Work Order ID 90960

Item Name: Crosstube Turning Detail

DART AEROSPACE LTD	Work Order:	90960
Description: Crosstube Assembly (412 High Aft)	Part Number:	D412-664-243
Inspection Dwg: D412-664-243 Rev: E		Page 1 of 2

DRAWING NO. D412-664-243	TITLE CROSSTUBE ASSEMBLY (412 HI AFT)	REV. E	DART AEROSPACE LTD ENGINEERING ORDER		D.E.O. NO. D412-664-243-E-1	SHEET NO. SHEET 1 OF 2	SCALE NTS
DRAWN	CHECKED	MFG. APPR.	APPROVED		DE APPR.		
DATE 11.03.31	DATE 11/03/31	DATE 11.03.31	DATE 11/03/31		DATE 11.03.31

**D412-664-243
ASSEMBLY DETAIL**

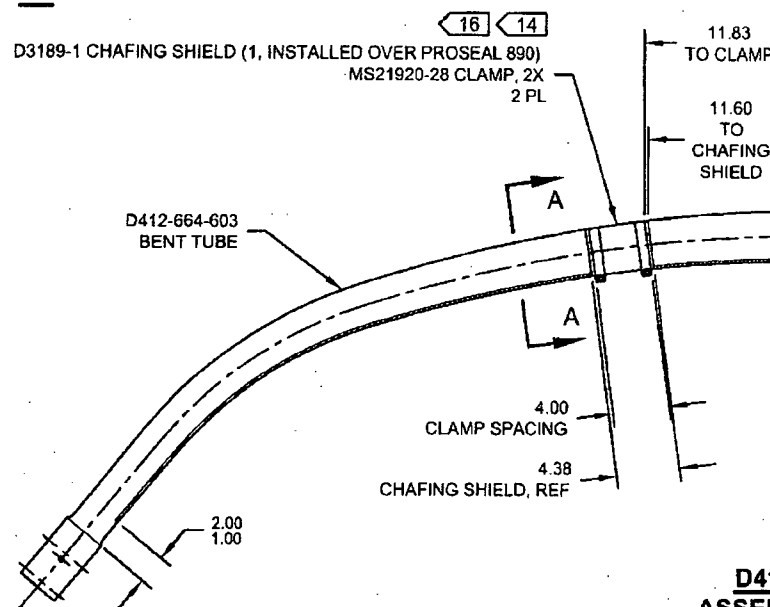
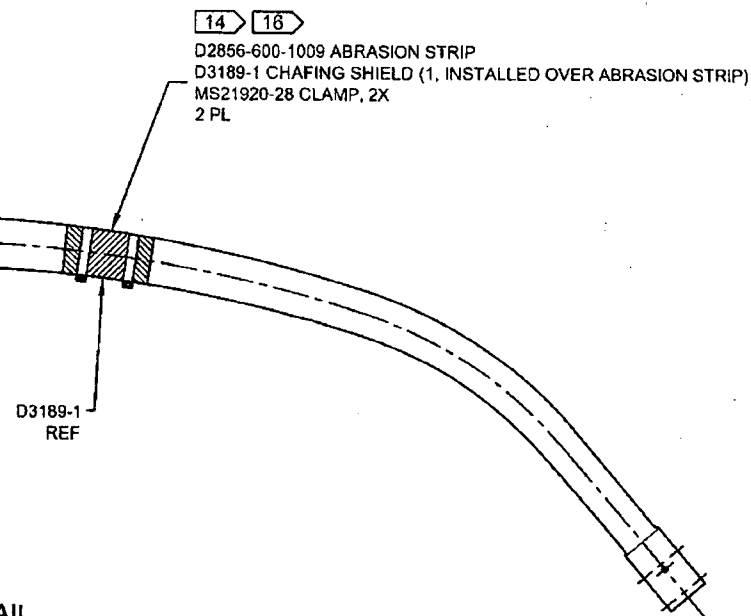
PURPOSE:

REMOVED ABRASION STRIP IN FAVOR OF A THIN LAYER OF PROSEAL 890. UPDATE INSTALLATION OF CHAFING SHIELDS AND REDUCE TORQUE TO 40-50 IN-LBS. THIS ENGINEERING ORDER SUPERCEDES DEO D412-664-243-E-1.

IS:

WAS:
